# RENESAS TECHNICAL UPDATE

Product Category	MPU/MCU		Document No.	TN-SH7-A881A/E	Rev.	1.00
Title	SH7751 Group, SH7751R Group English Manual Revision Number, Electrical Characteristics and Package Dimensions Manual Correction		Information Category	Technical Notification		
Applicable Product	SH7751 Group, SH7751R Group	Lot No.	Reference Document	SH7751 Group, SH7751R Group User's Manual: Hardware (R01UH0457EJ0301, R01UH0457EJ0401)		
		All lots

Regarding SH7751 and SH7751R Groups, there are manual corrections about the English manual revision number, electrical characteristics (AC specifications) and package dimensions.

Figure 23.12 (2) Pin Drive Timing for Software Standby Mode

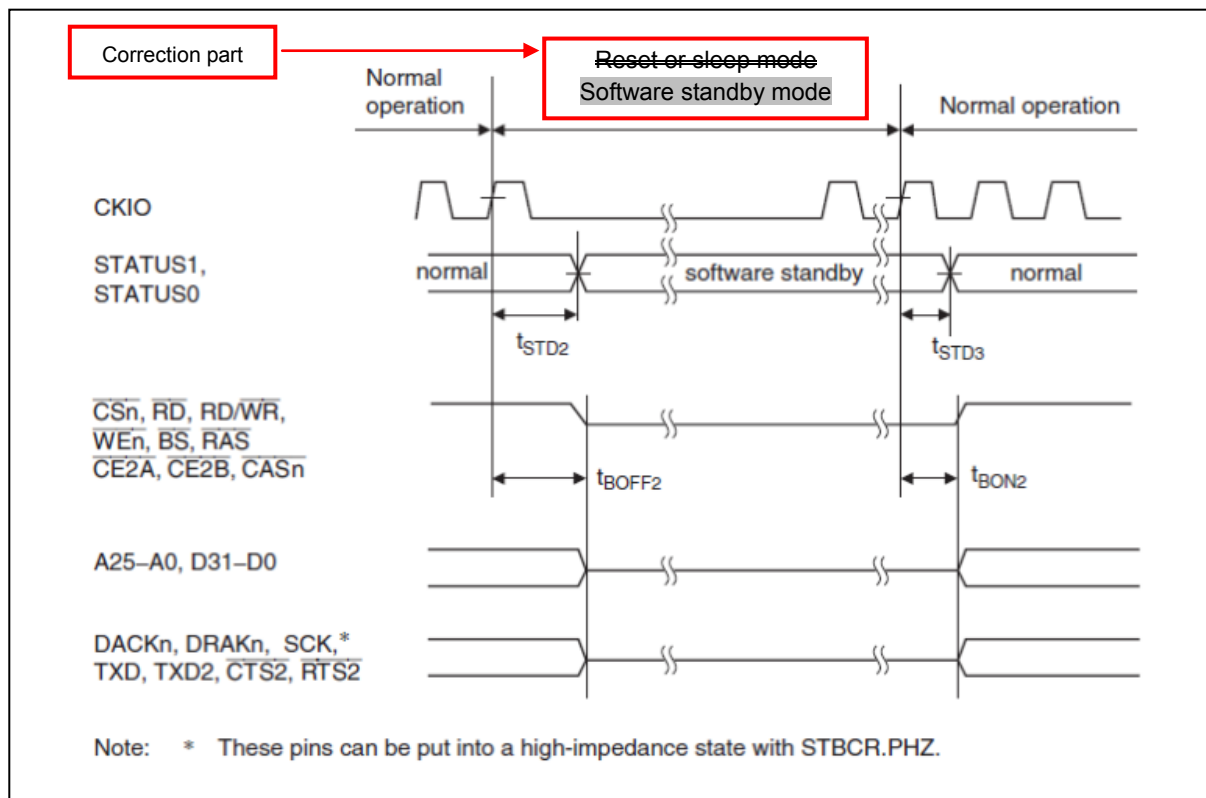
3) SH7751 and SH7751R (Page 1015, Figure 23.12 (2) Pin Drive Timing for Software Standby Mode)

Operation mode description is corrected as follows.

Figure B.4 Package Dimensions  
(256-pin BGA: HD6417751RBA240HV)

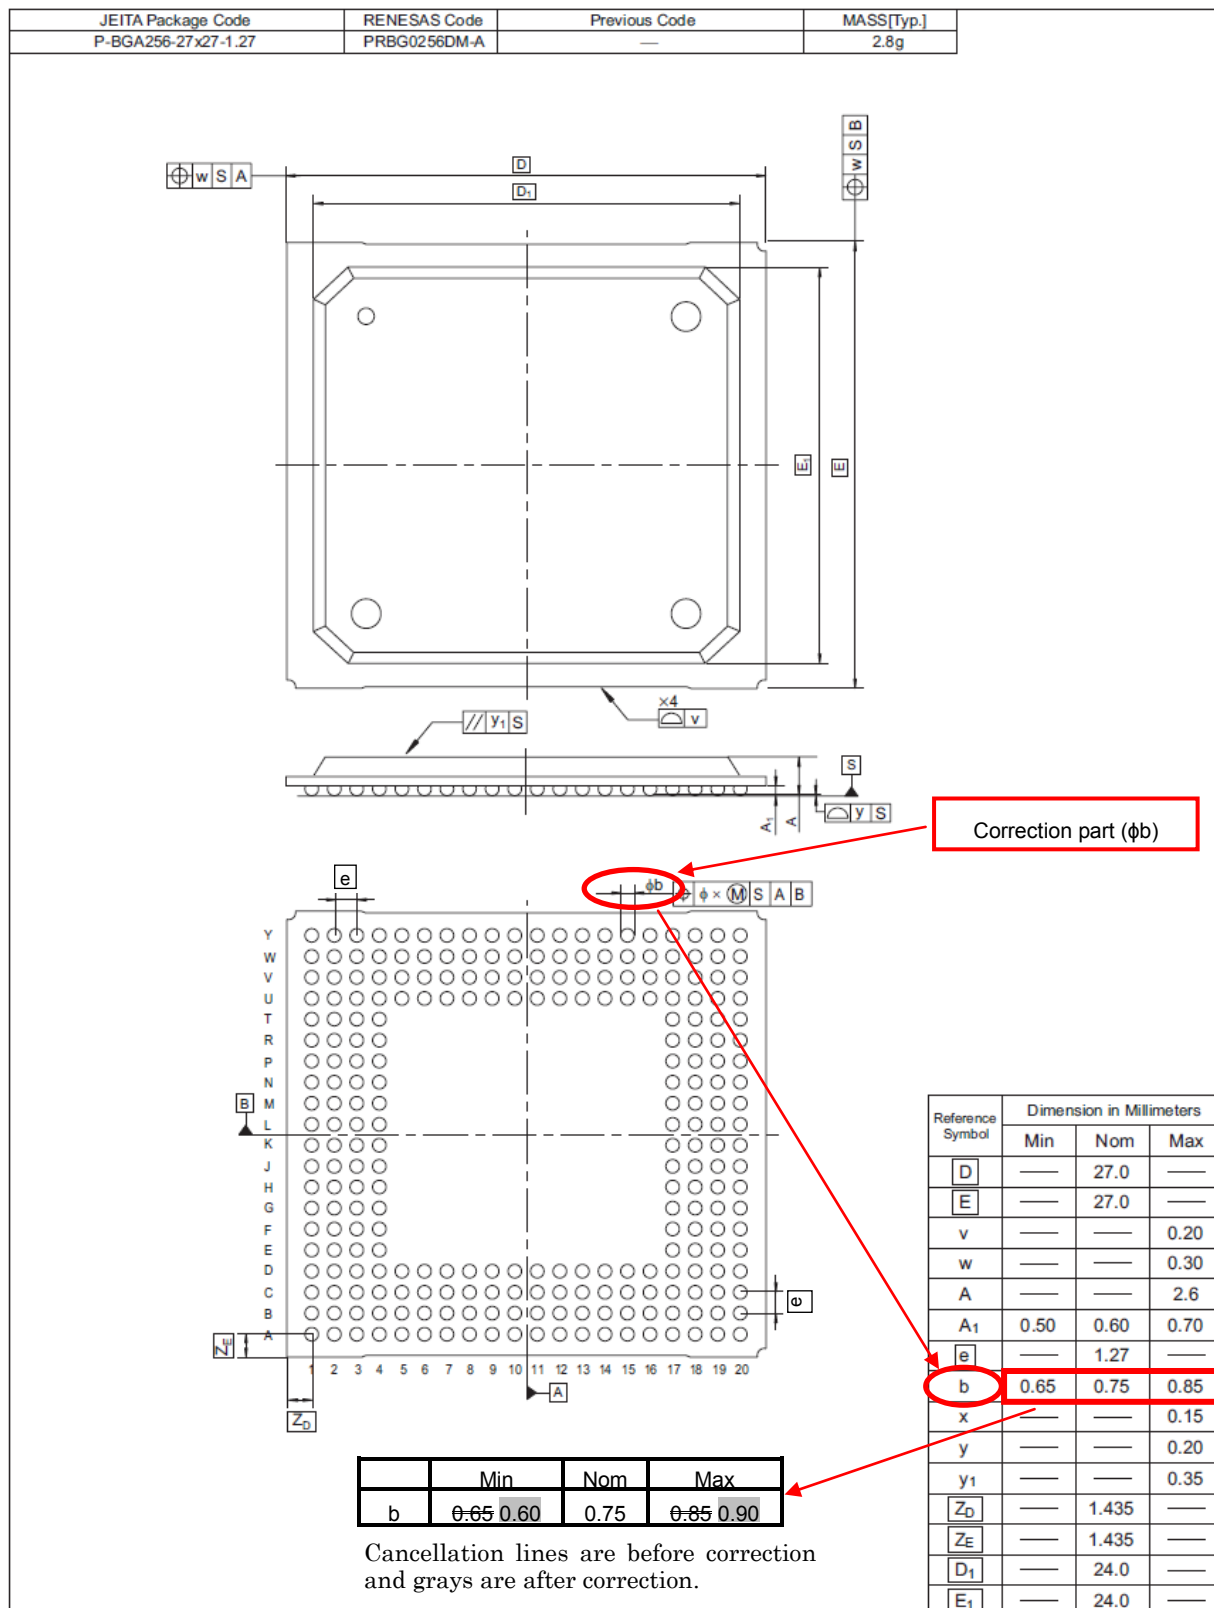
- SH7750R (Page 1094, Figure B.4 Package Dimensions (256-pin BGA: HD6417751RBA240HV))

Ball diameter ( $\phi b$ ) specification of the HD6417751RBA240HV is corrected as follows.
